**From:** Rikhoff, Jeffrey  
**Sent:** Thursday, August 12, 2010 4:27 PM  
**To:** Eccleston, Charles  
**Cc:** Imboden, Andy; Pham, Bo  
**Subject:** RE: Salem and Hope Creek Chapter 4 - Technical review of Land Use, Socioeconomics, and EJ Sections

Attached is my redline/strikeout markup, corrections, and comments on Salem HCGS SEIS Chapter 4. I revised and corrected the land use, socioeconomics, and environmental justice sections. Overall, AECOM did a good job on these sections. Most of the revisions reflect updates to the discussions.

Figure 4-1. Census 2000 minority block groups within a 50-mi radius of Salem and HCGS

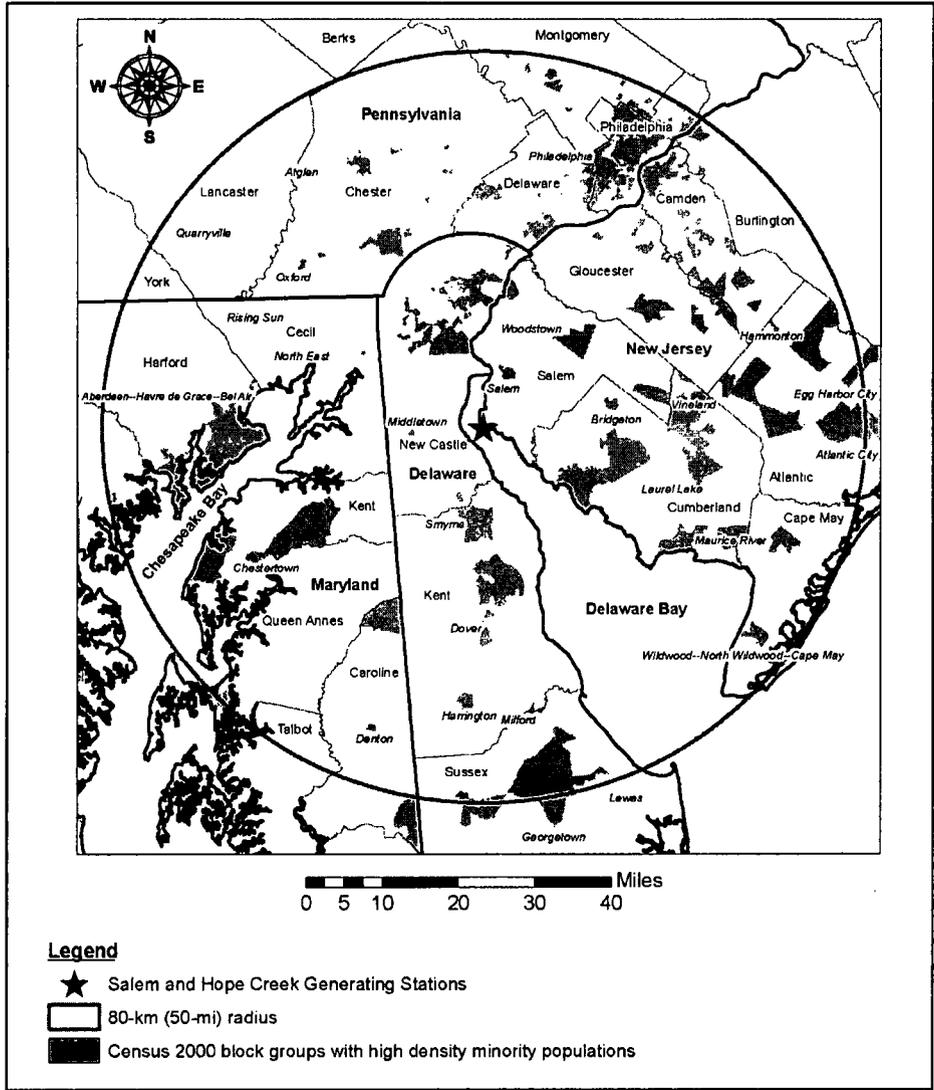
Comment [JJR3]: Delete the words "high density" in figure legend.

**Figure 4-2. Census 2000 low-income block groups within a 50-mi radius of Salem and HCGS**

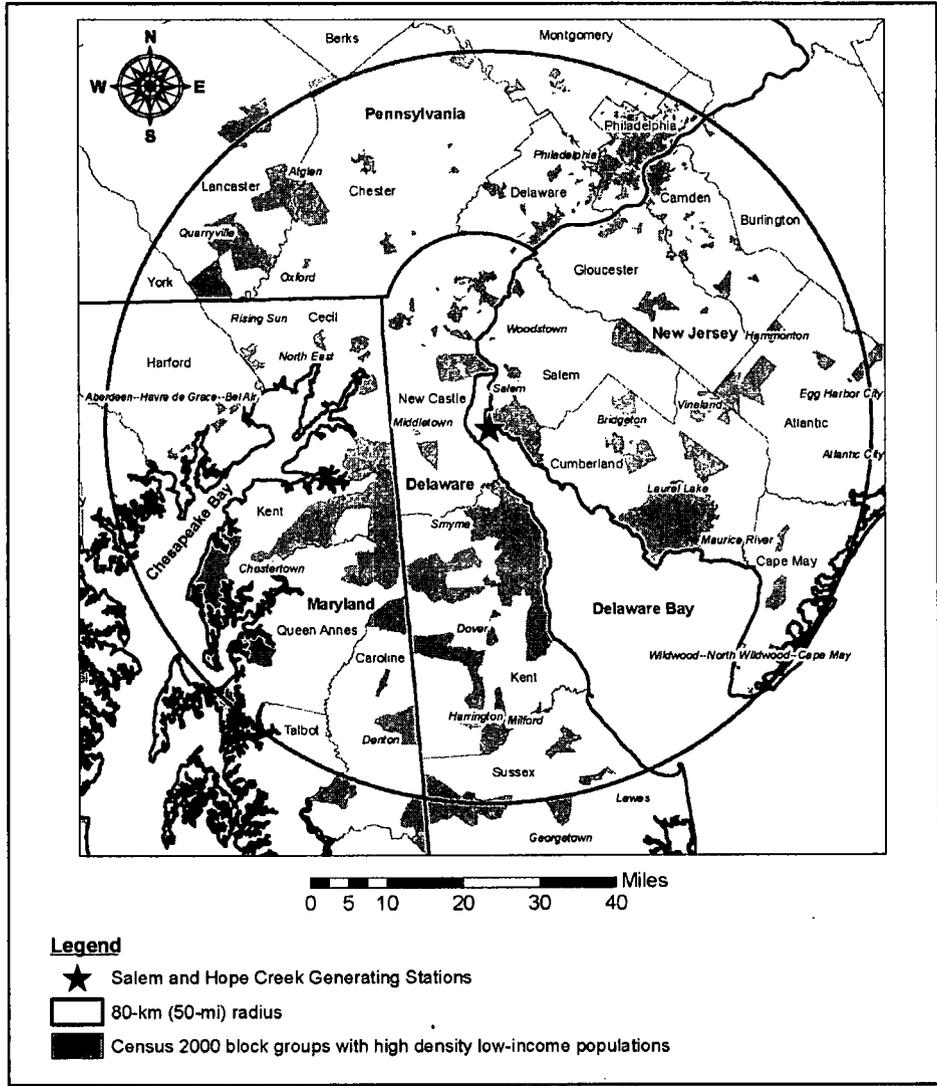
**Comment [JJR4]:** Delete the words "high density" in figure legend.
